Integrus Architecture, P.S.
117 S Main Street
Seattle, WA 98104
(206) 628-3137

The additions, clarifications and corrections contained herein shall be made to the Project Manual, Drawings and Schedules for the above referenced project, and shall be included in the scope of work and proposal to be submitted.

Sartori Elementary School

DWG. #: **ADL-018**
 JOB #: 21607.00
 DRAWN BY: NAL
 DATE: 03/17/17
 REF. DOC.: ADDENDUM 3

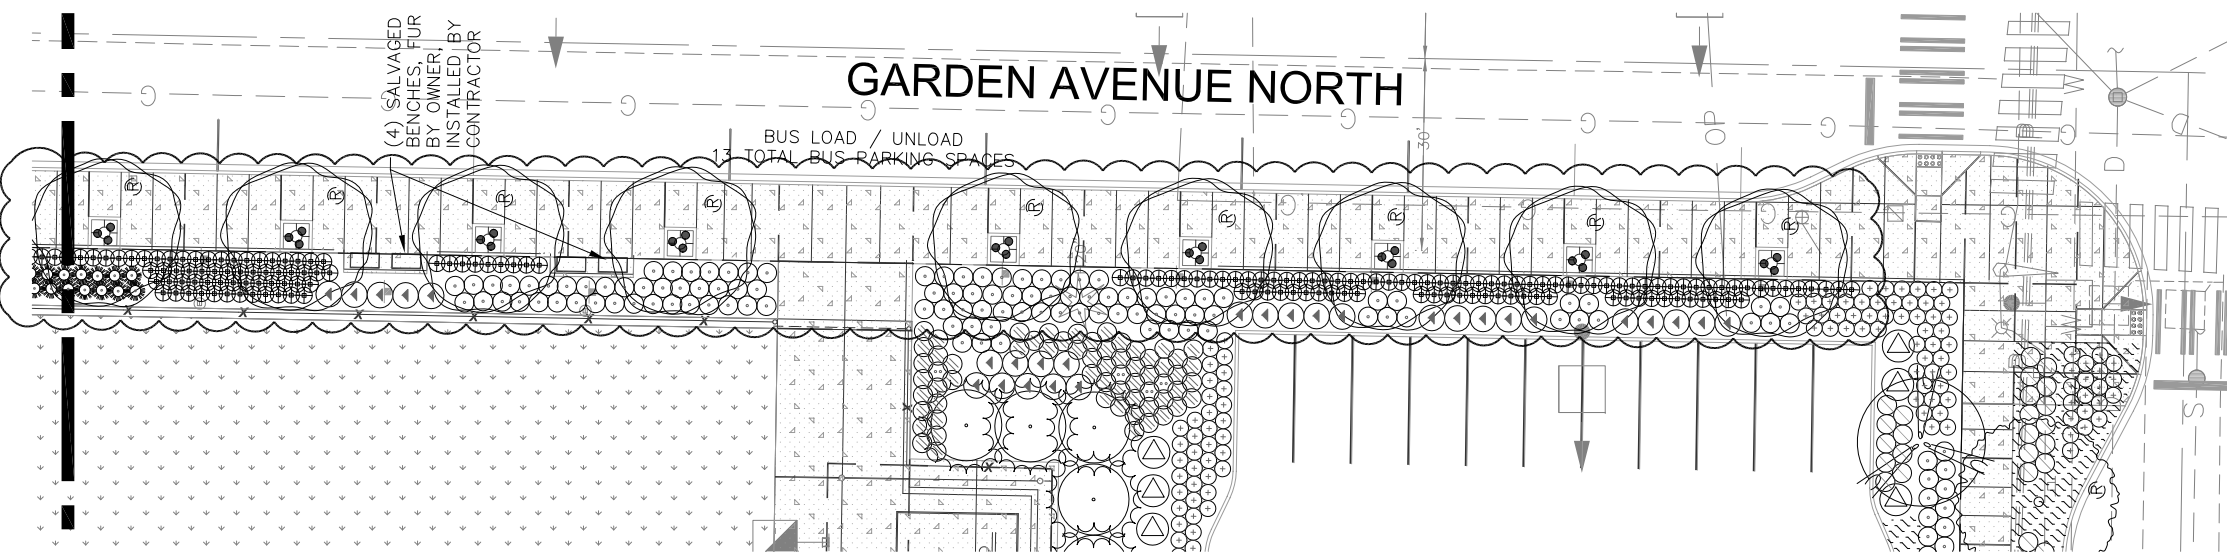
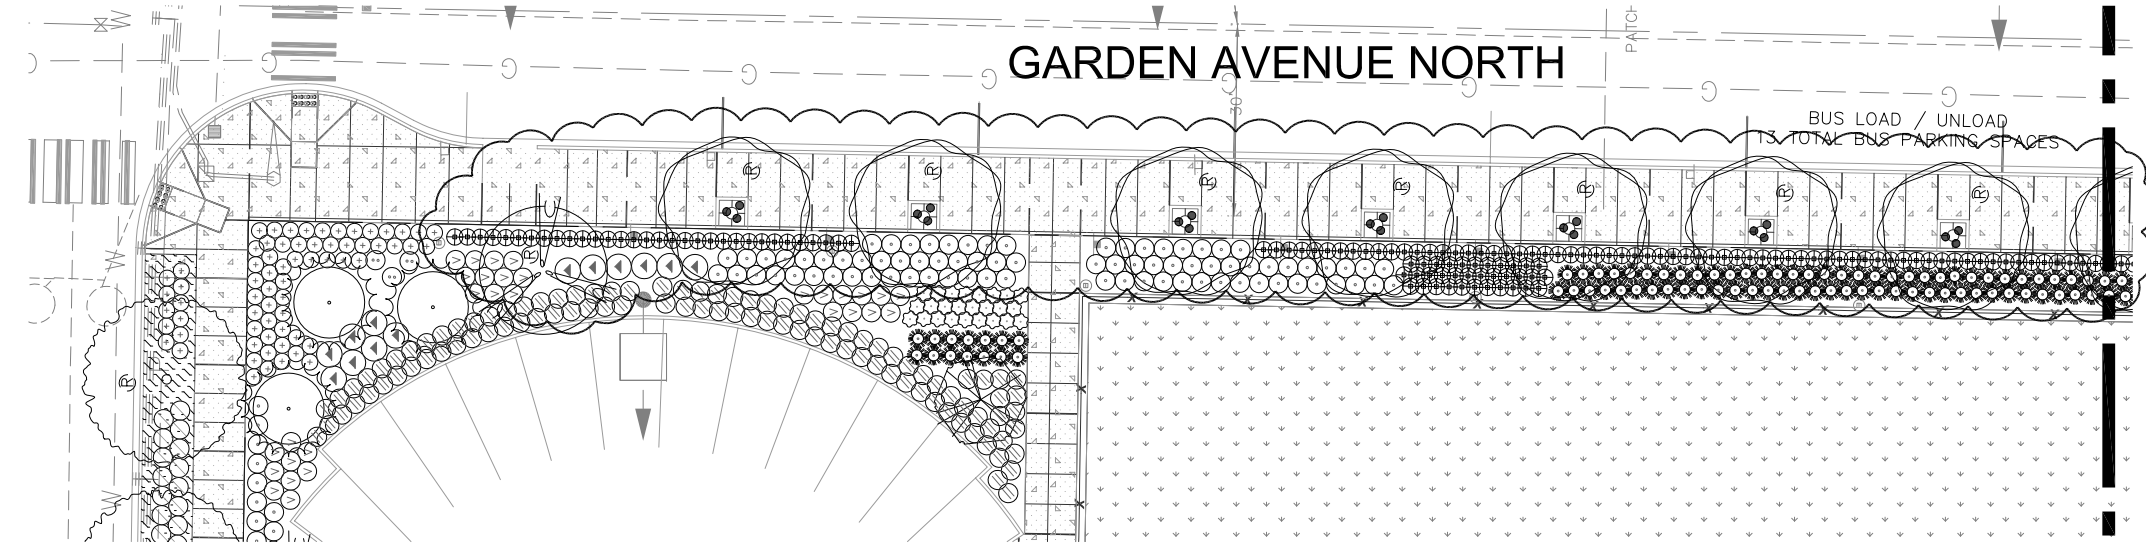
ADD #03 Added Tree Grates and revised scoring in sidewalk along Garden Avenue North per attached ADL-018.

LANDSCAPE PLAN - GARDEN AVENUE NORTH

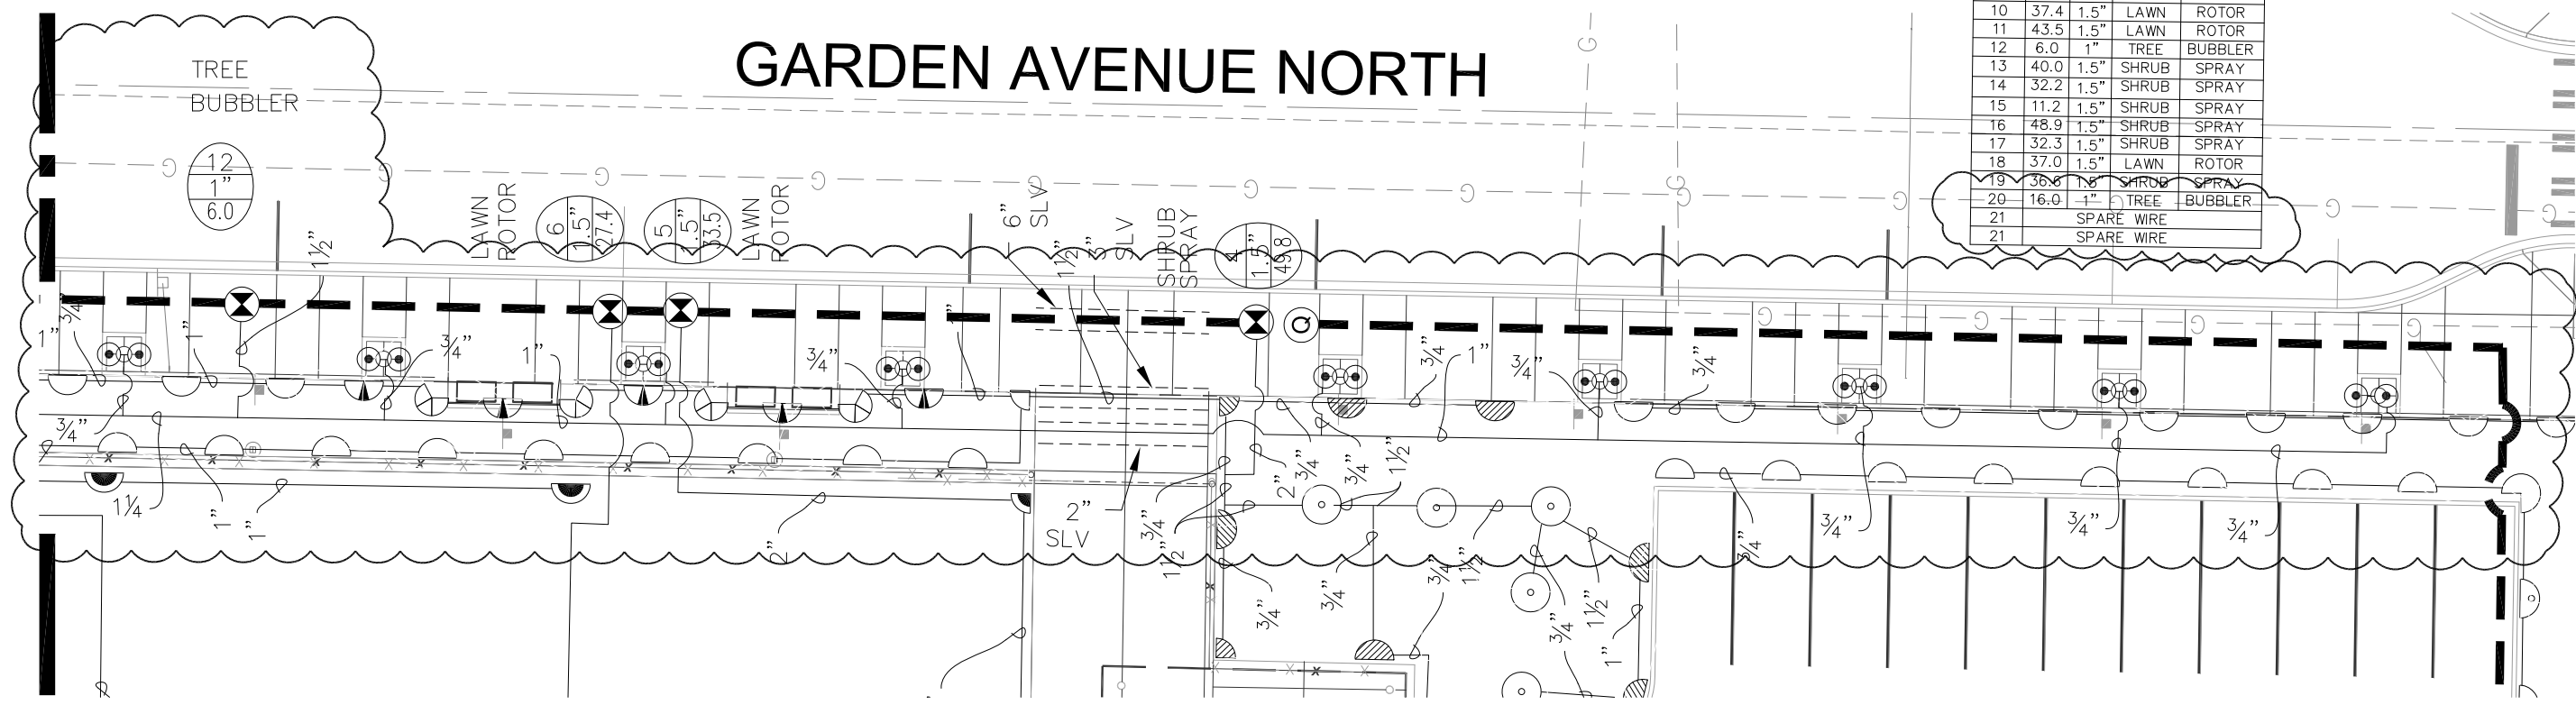
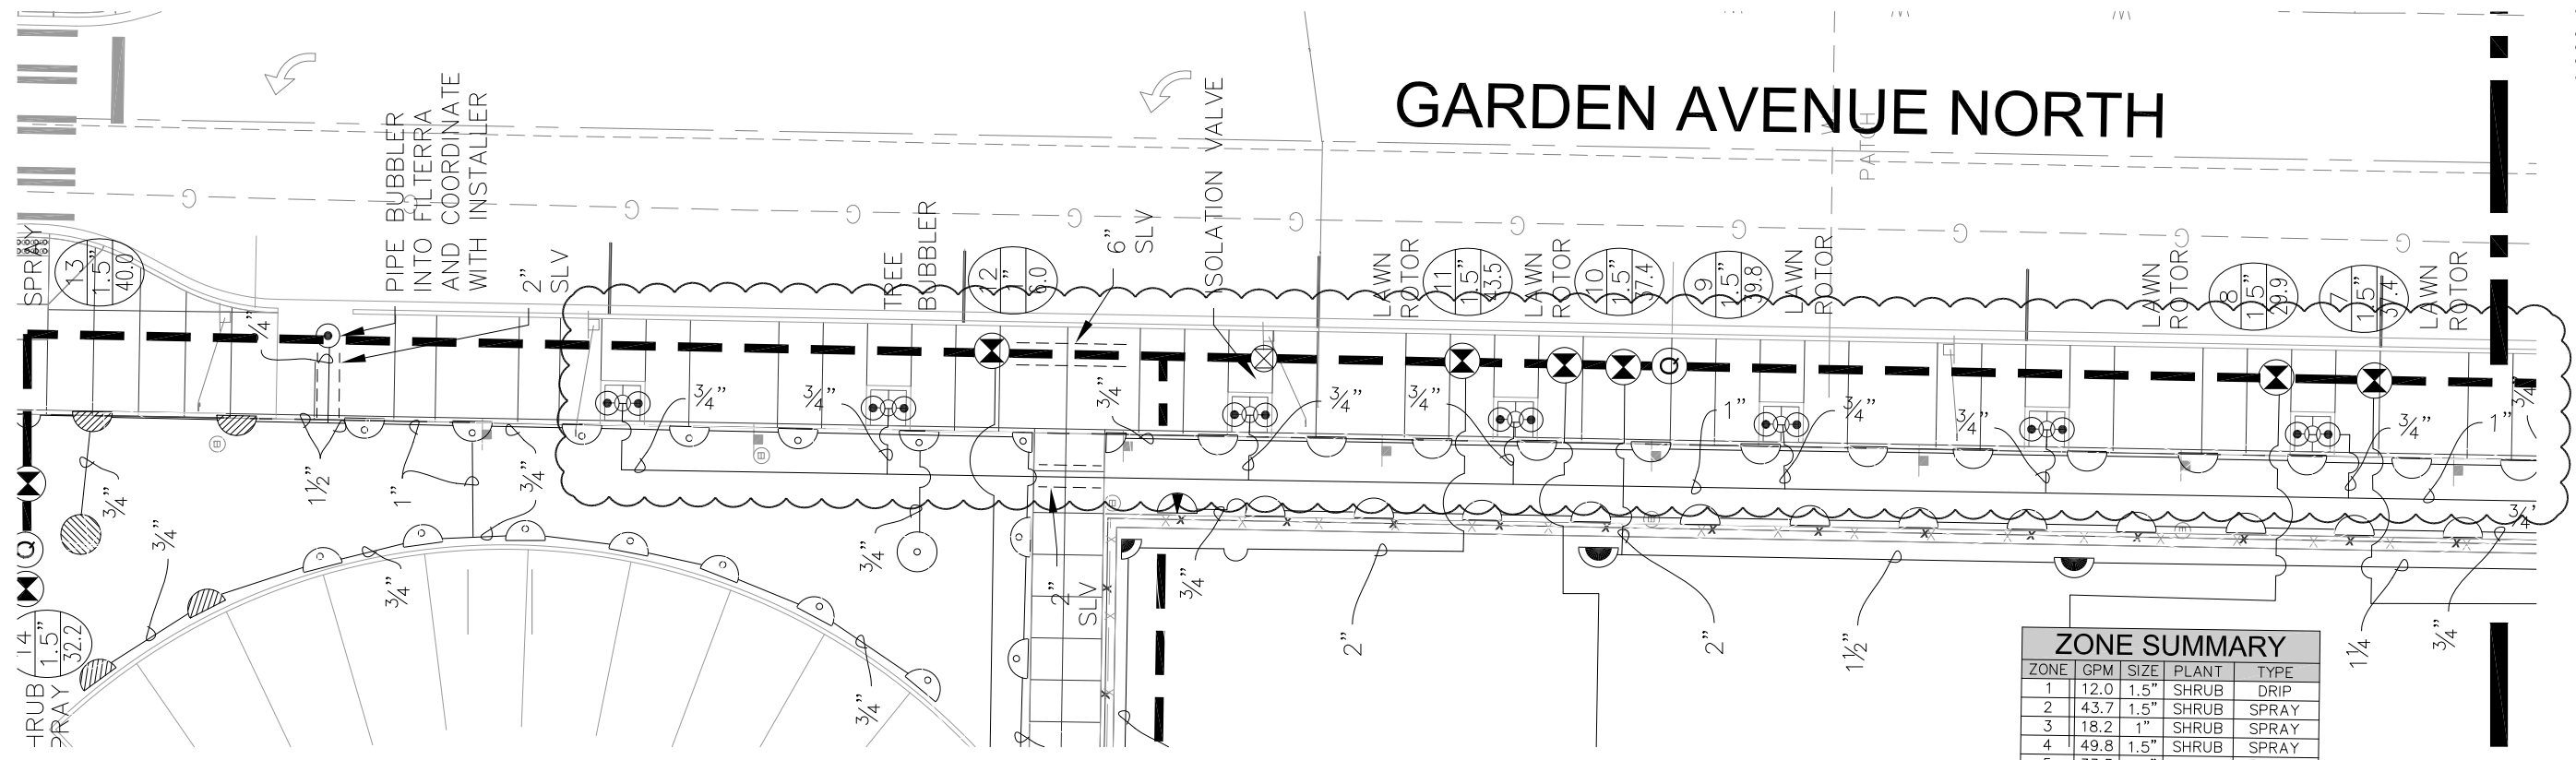
ADD #03 Relocated Trees from buffer to new tree grate locations in sidewalk along Garden Avenue North per attached ADL-019. Add additional shrubs to the buffer in locations where trees had been. Changed one *Carpinus betulus* 'Fastigiata' / European Hornbeam to *Styrax obassia* / Fragrant Snowbell at the north end of Garden Avenue within the buffer.

DWG. #: **ADA-020**
JOB #: 21607.00
DRAWN BY: NAL
DATE: 03/17/17
REF. DOC.: ADDENDUM 3

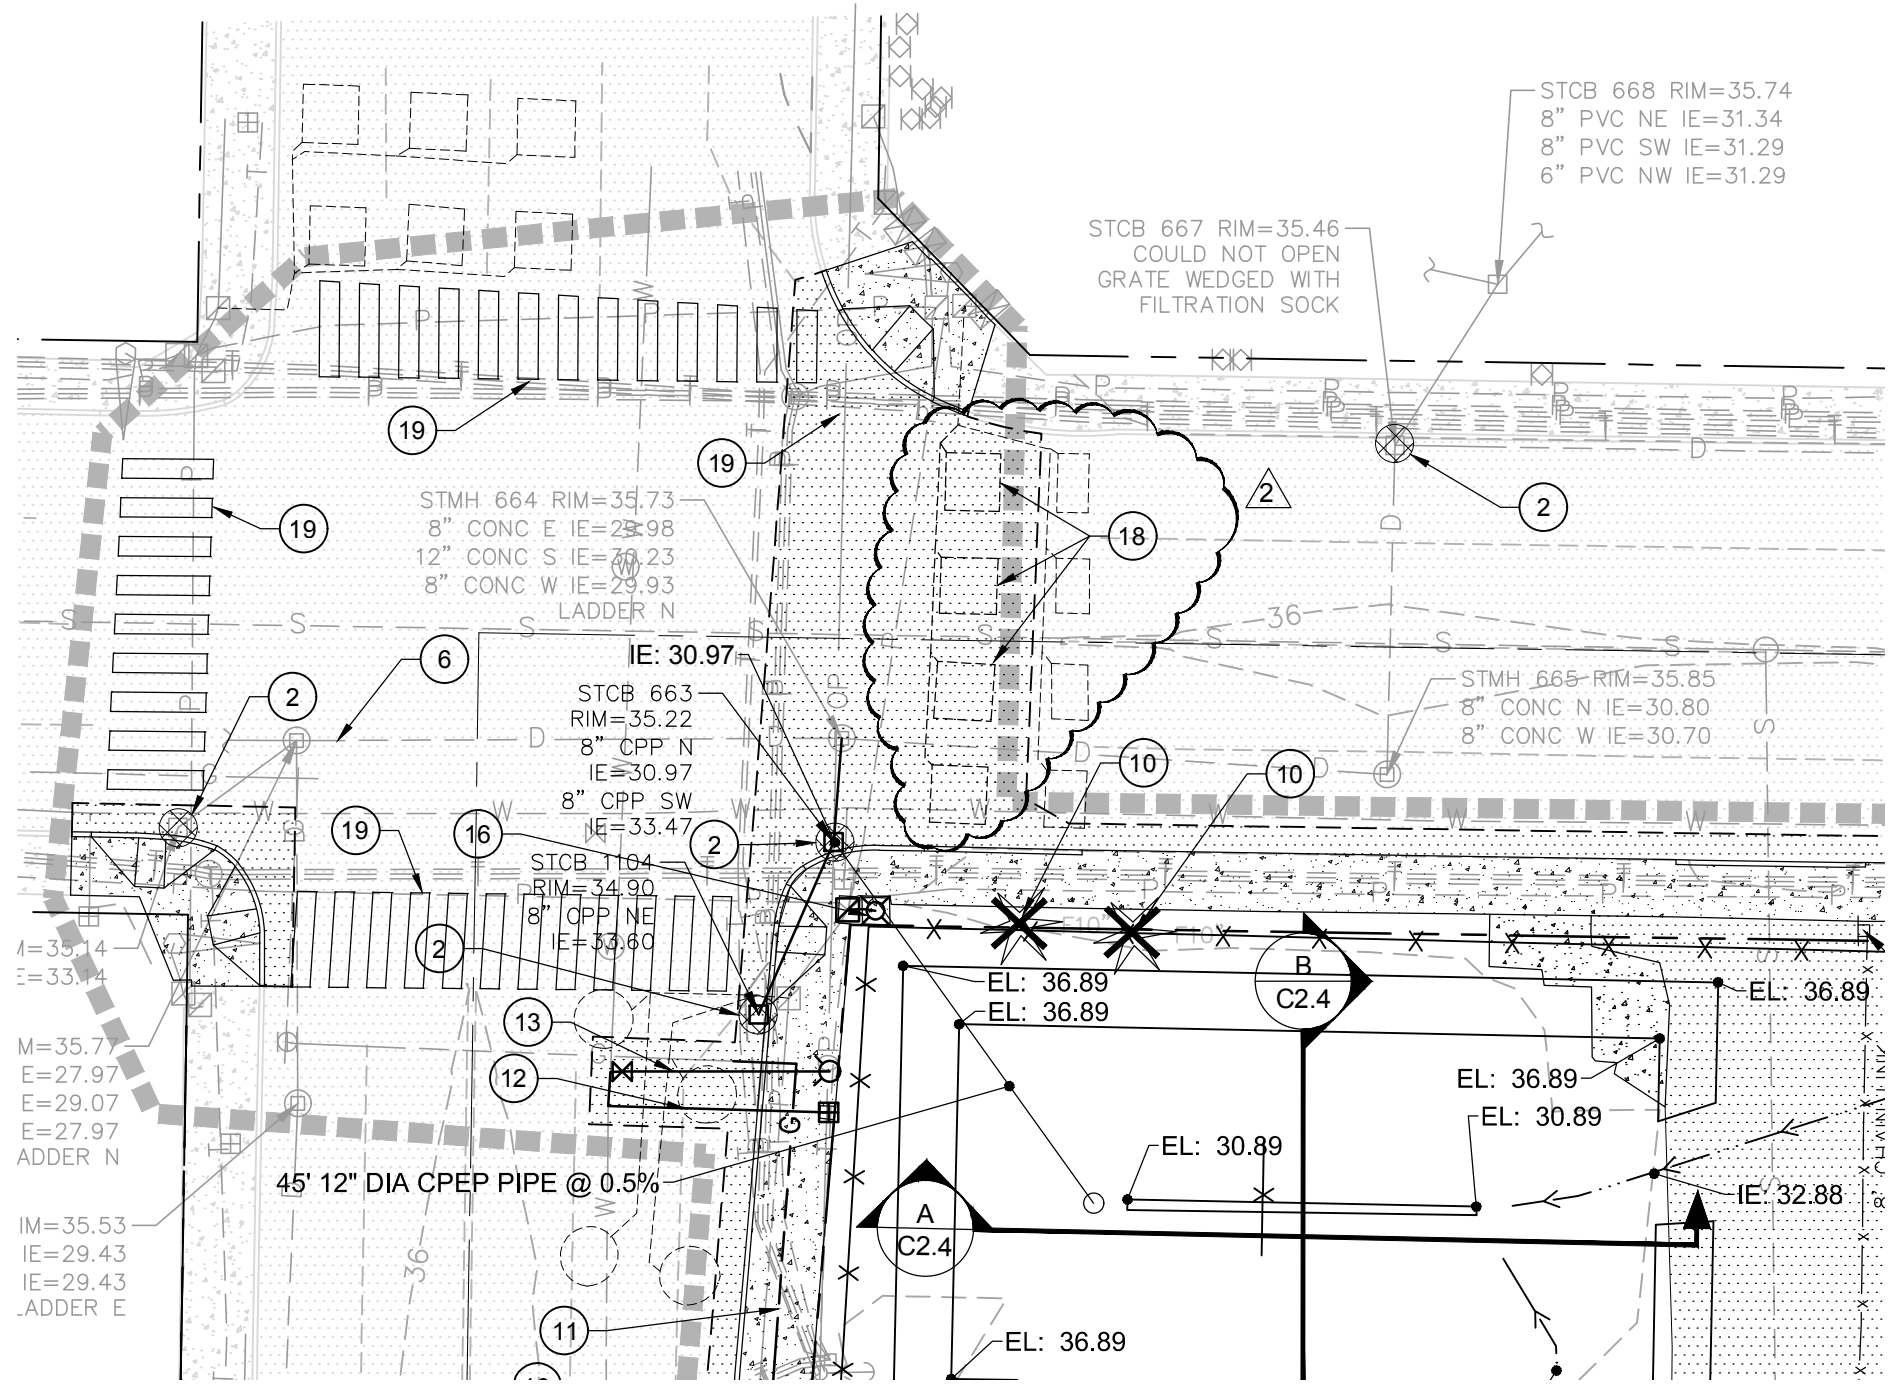
ADD #03 Revised Zone Summary Chart to include additional valve per attached ADL-020. Added bubbler sprinkler heads for the trees in grates along Garden Avenue North, one additional control valve, required pipe, and two additional sleeves.
